# AIA Document G701™ – 2017

## Change Order

**PROJECT:** (Name and address)  
Williamson County  
Animal Shelter Expansion  
1855 SE Inner Loop  
Georgetown, TX 78626

Change Order No. 3 includes the below listed Vaughn Change Proposals # 11-#17. For Vaughn Project No. 2491-01.

**A.3-5.42**  
 Plot Date: 09/27/17

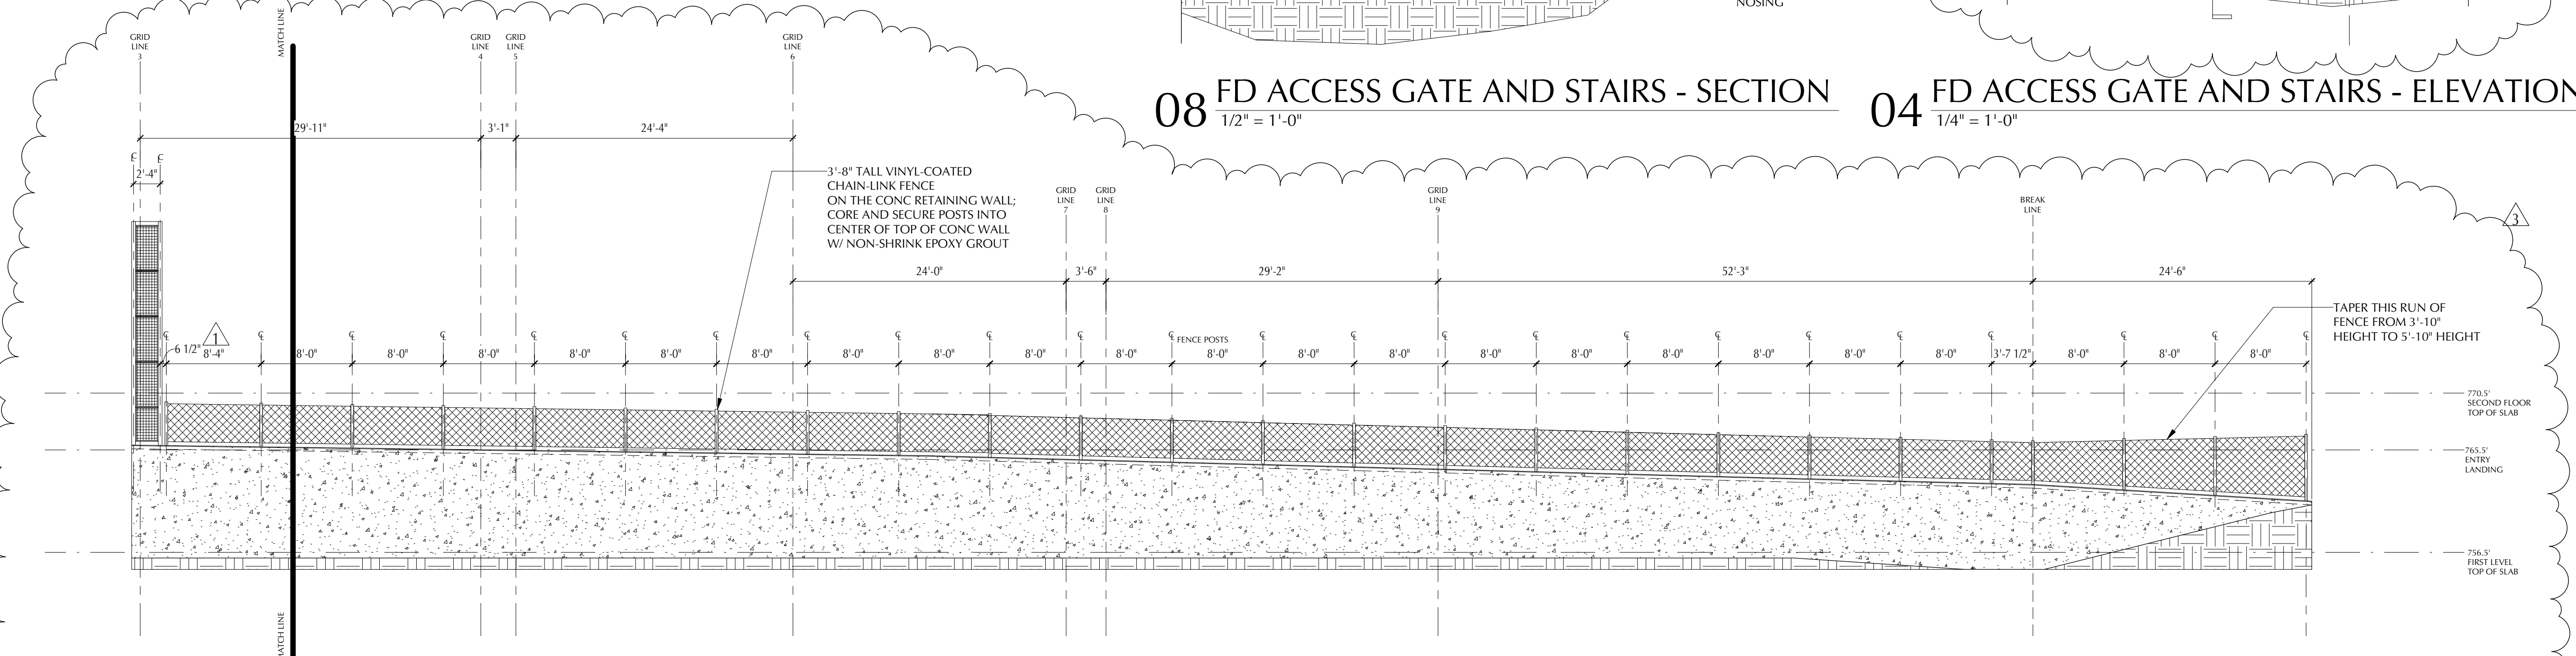
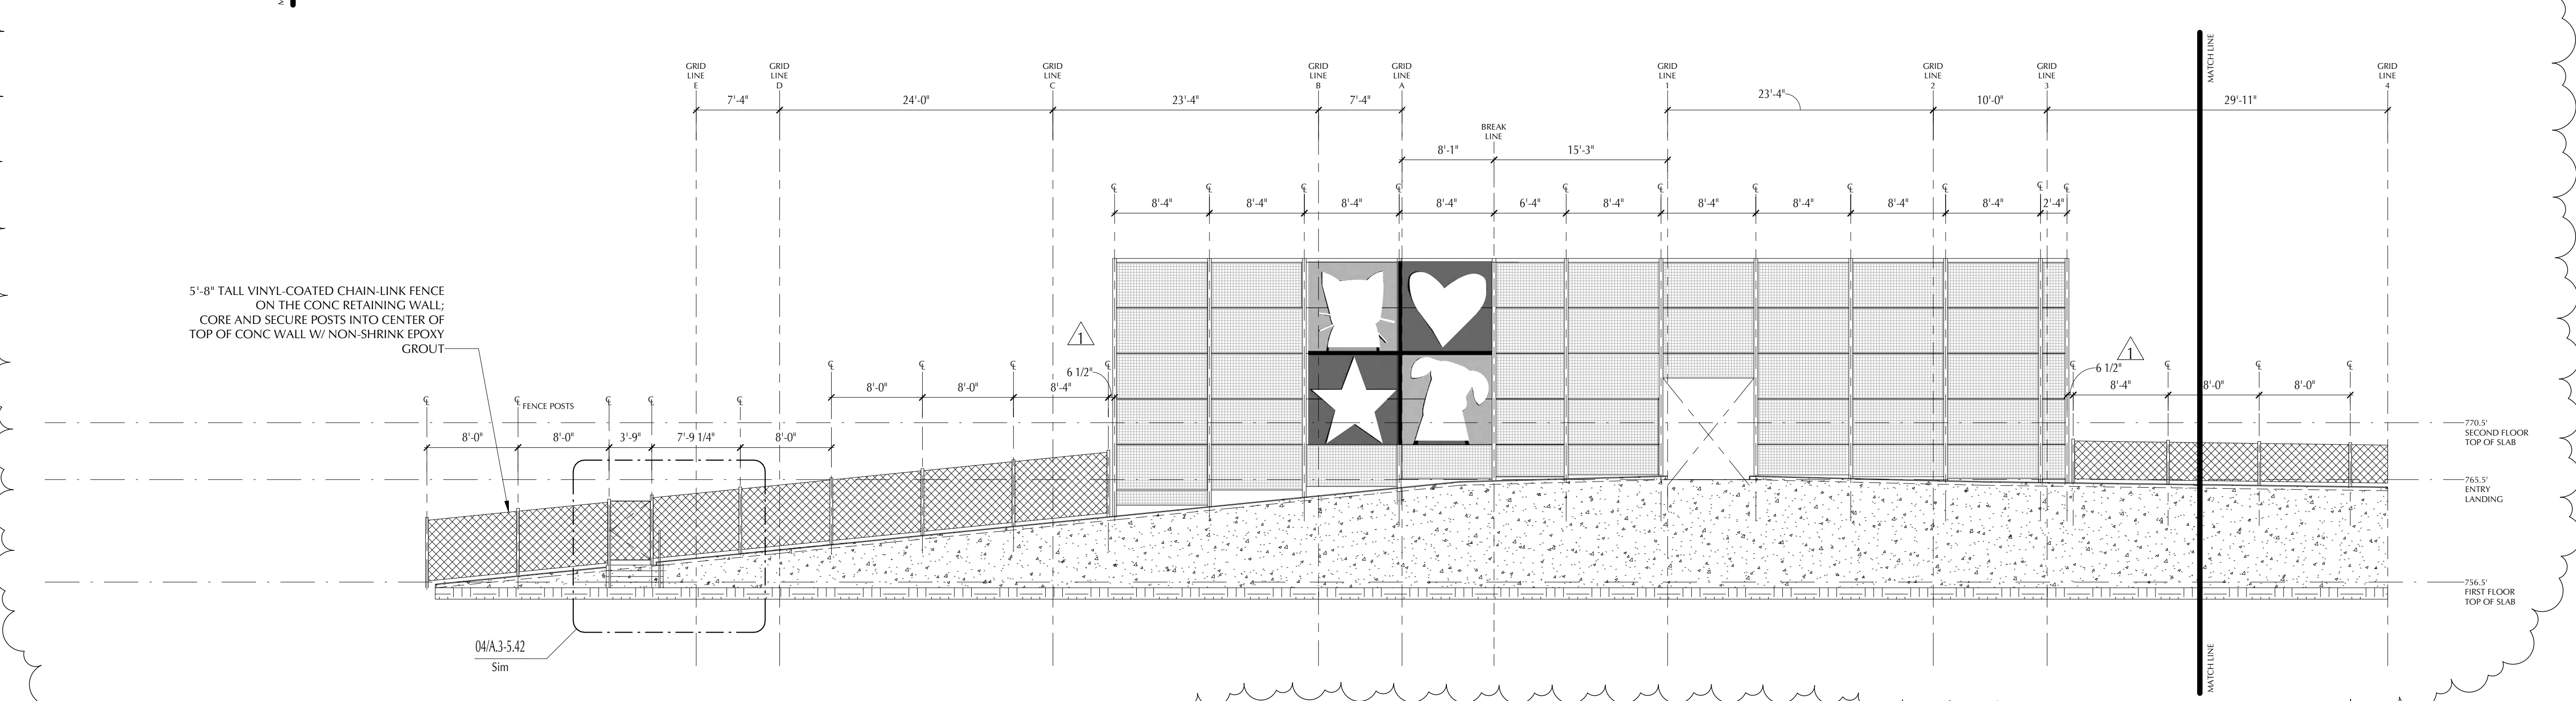
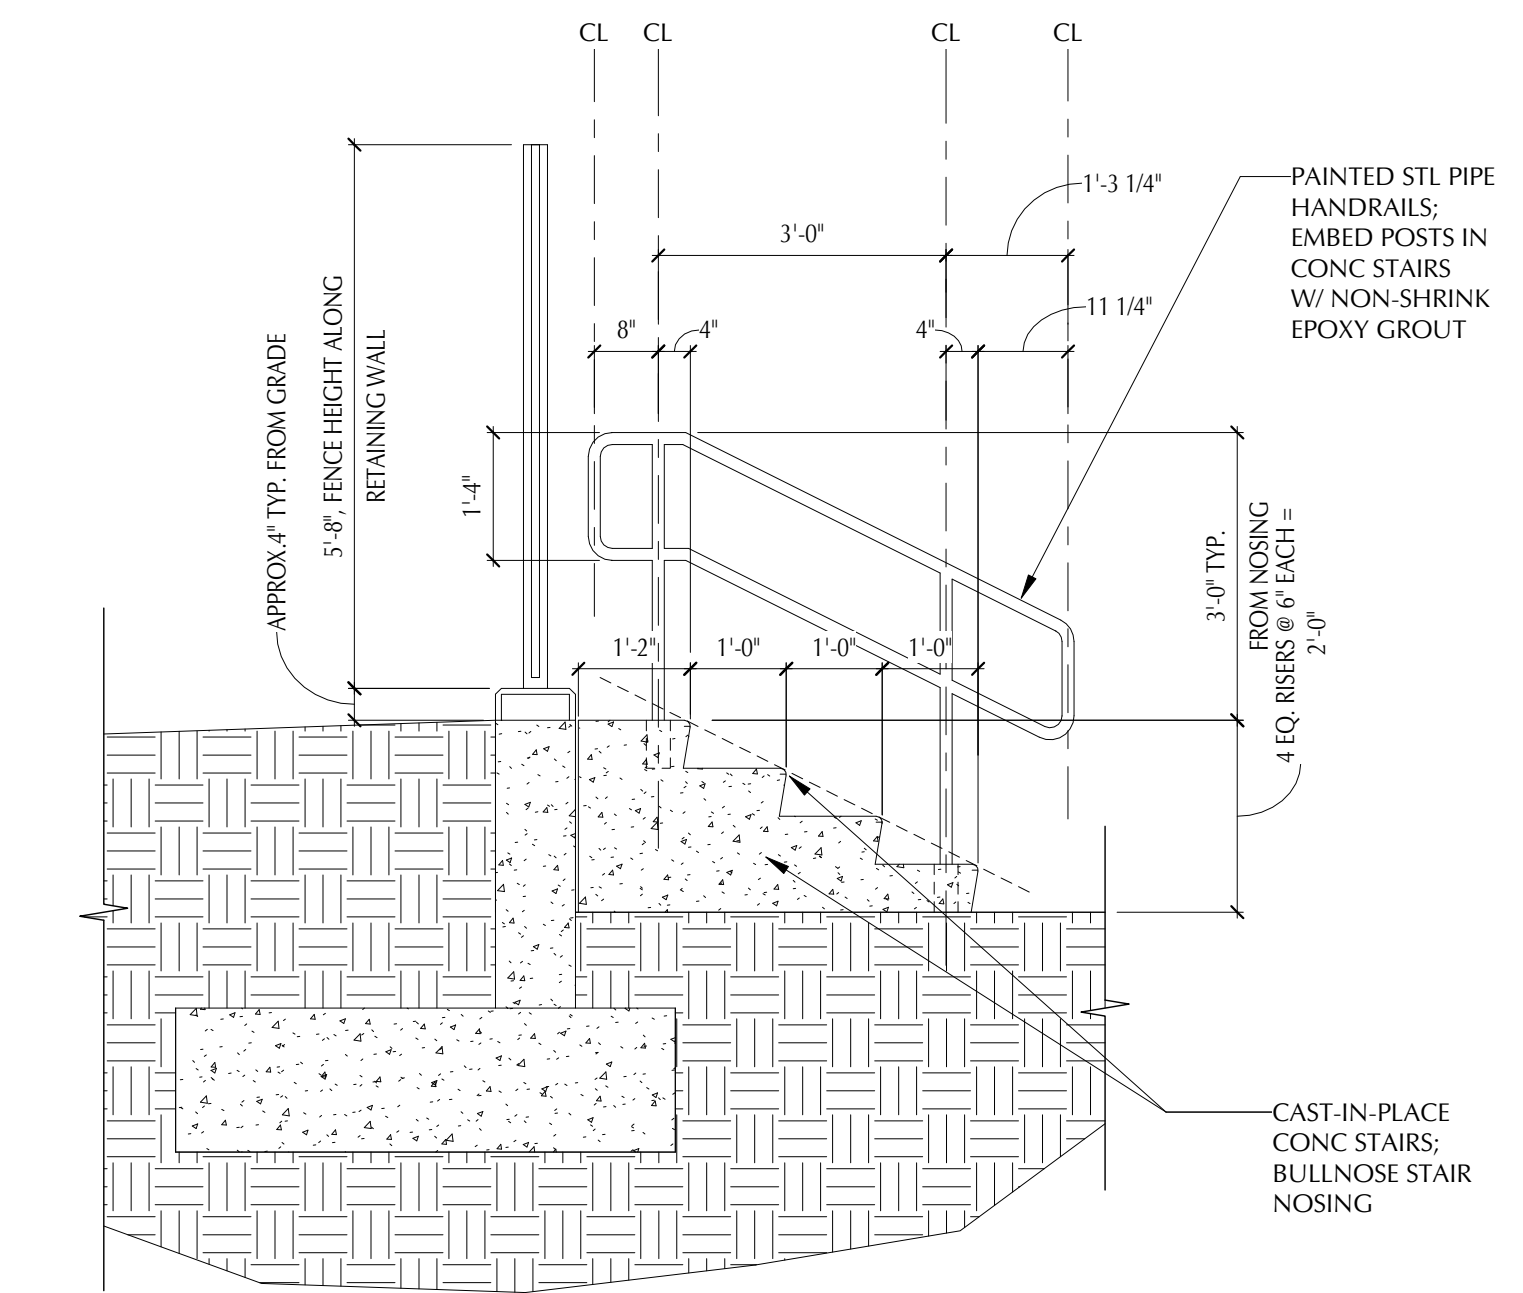
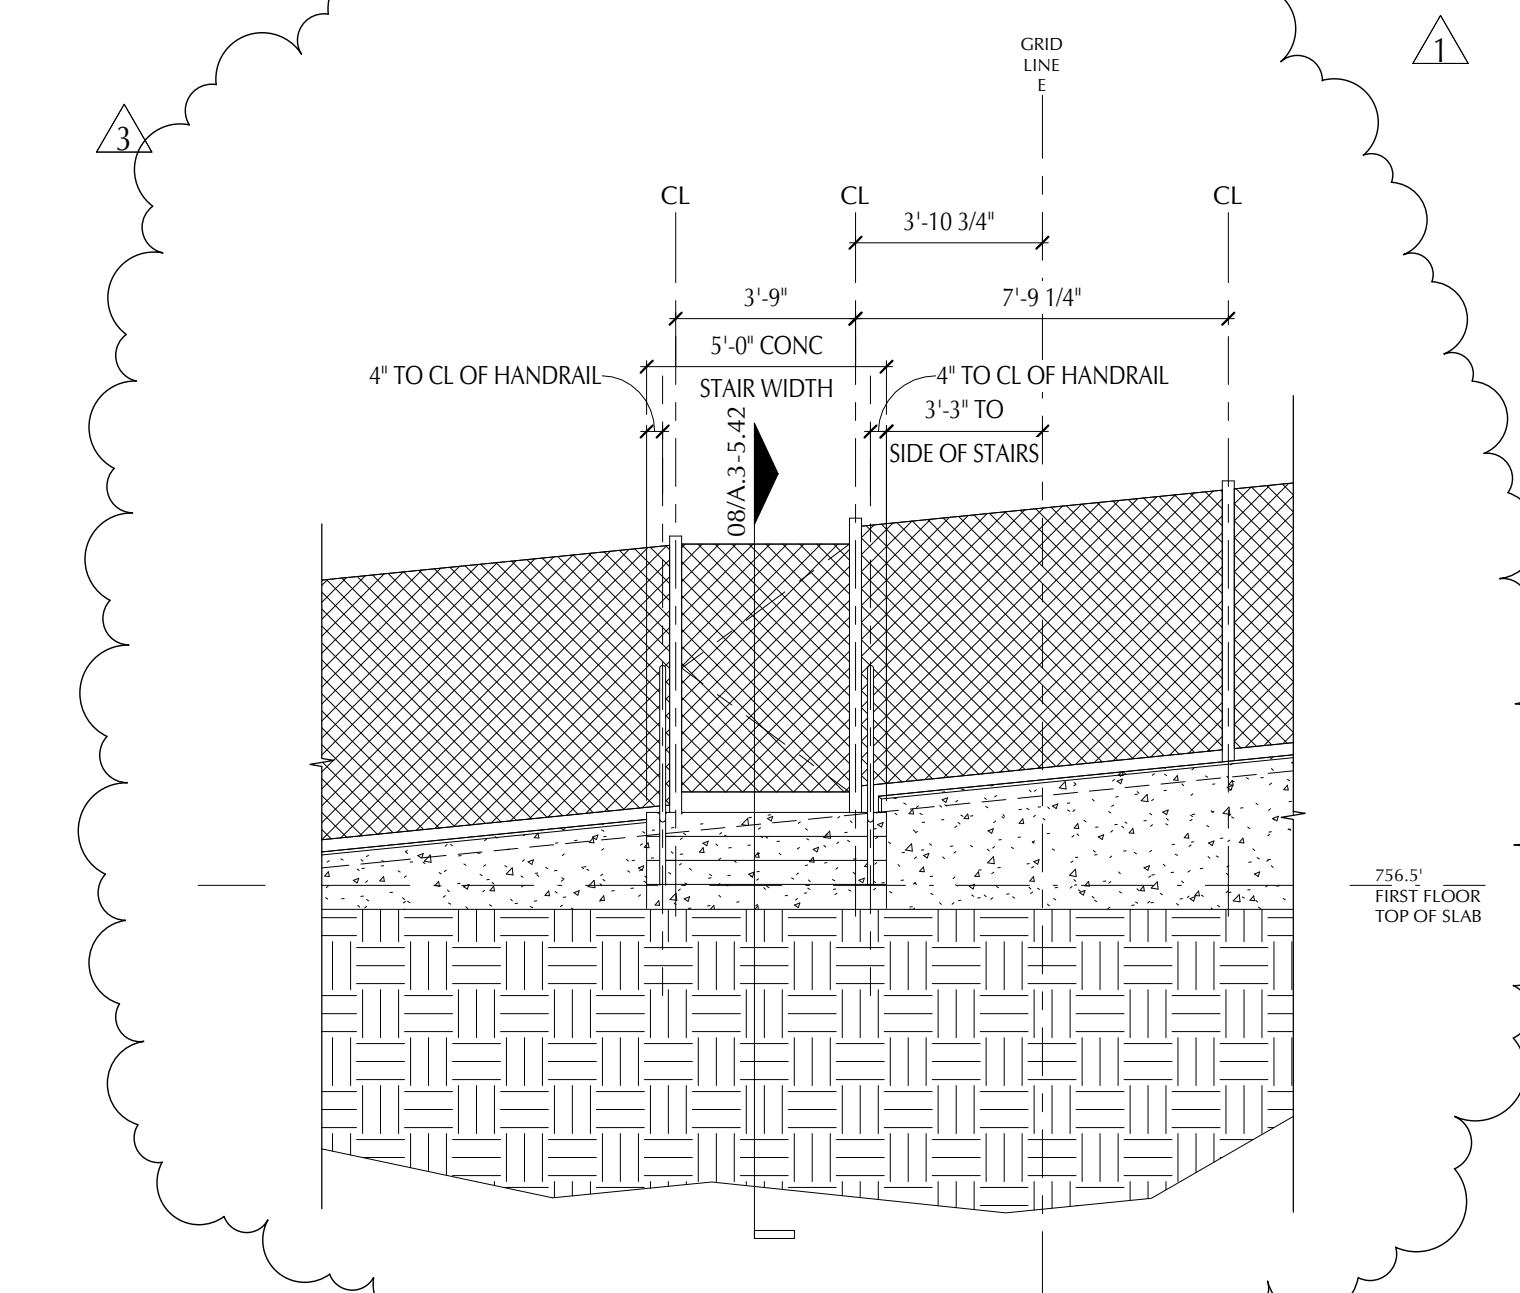
2) Reference sheets S.3-2.03, A.3-5.40, A.3-5.42, A.3-5.41 and attached Greenscreen detail. Typical Greenscreen panels are 8 ft wide and require 1/2" clear space per side to accommodate the mounting brackets (see attached). With the 4" HSS columns, the 8'4" spacing from center of post to center will not be enough to install the panels as recommended. The spacing will need to be 8'5" center of column to column. Can the typical spacing for the columns be changed and the end sections at each run be reduced to accommodate this?

The spacing for the greenscreen support columns will remain as-drawn, and each panel can instead be reduced in width by 2". See revised drawing sheets A.3-5.41 and A.3-5.42 for updated screen wall and retaining all elevations which coordinate w/ the site grading on the approved Site Development drawings.
